Project	IEEE 802.16 Broadband Wireless Access Working Group < http://ieee802.org/16 >	
Title	Service flow management for RS	
Date Submitted	2007-03-05	
Source(s)	Kenji Saito, Takashi Inoue KDDI R&D Laboratories Inc. Hikarino-oka 7-1, Yokosuka, Kanagawa 239-0847, Japan	Voice: +81 46 847 6347 Fax: +81 46 847 0947 saito@kddilabs.jp
	Shulan Feng, Yanling Lu, Ting Li, Liangliang Zhang Hisilicon Technologies Harbour Building, No.8, Dongbeiwang West Road, HaiDian District, Beijing, China	Voice: 86-10-82829010 Fax: 86-10-82829075 luyanling@hisilicon.com fengsl@huawei.com
	Yuefeng Zhou Fujitsu Laboratories of Europe Ltd Hayes Park Central, Hayes End Road, Hayes, Middlesex, UB4 8FE, UK	Voice: +44 (0) 20 8573 4444 Fax: +44 (0) 20 8606 4539 Yuefeng.zhou@uk.fujitsu.com
	Masato Okuda Fujitsu Laboratories Ltd. Kamikodanaka 4-1-1, Kawasaki, 211-8588, Japan	Voice: +81-44-754-2811 Fax: +81-44-754-2786 okuda@jp.fujitsu.com

Re:	This contribution is a response to " IEEE 802.16j-07/007r2 Call for Technical Comments and Contributions regarding IEEE Project 802.16j" (2007-02-19)	
Abstract	This document proposes service flow management sequence through RS.	
Purpose	This document is provided in response fo

Table 125b – DSA initiated from SS through RS (Distributed scheduling case)

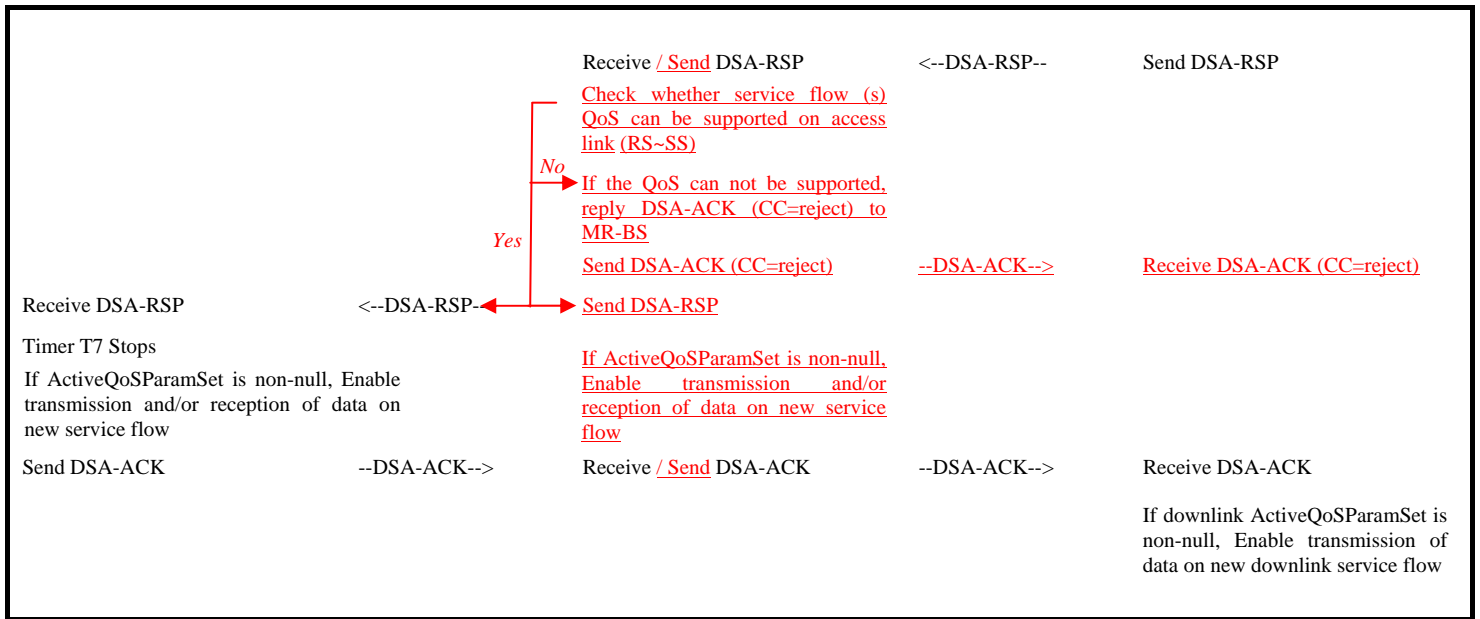
In MR distributed scheduling case, RS shall check whether the QoS requirements can be supported on access link (RS ~ SS) or relay link (RS ~ RS) based on the received DSA-RSP. If it can be supported, RS shall send DSA-RSP to the MS or its subordinate RS and send the DSA-ACK to the BS. Otherwise, RS shall respond DSA-RSP with DSA-ACK with CC=reject to the MR-BS.

The MR-BS checks whether the QoS requirements can be supported on relay link (MR-BS ~ RS). This process is illustrated in Table 125b.
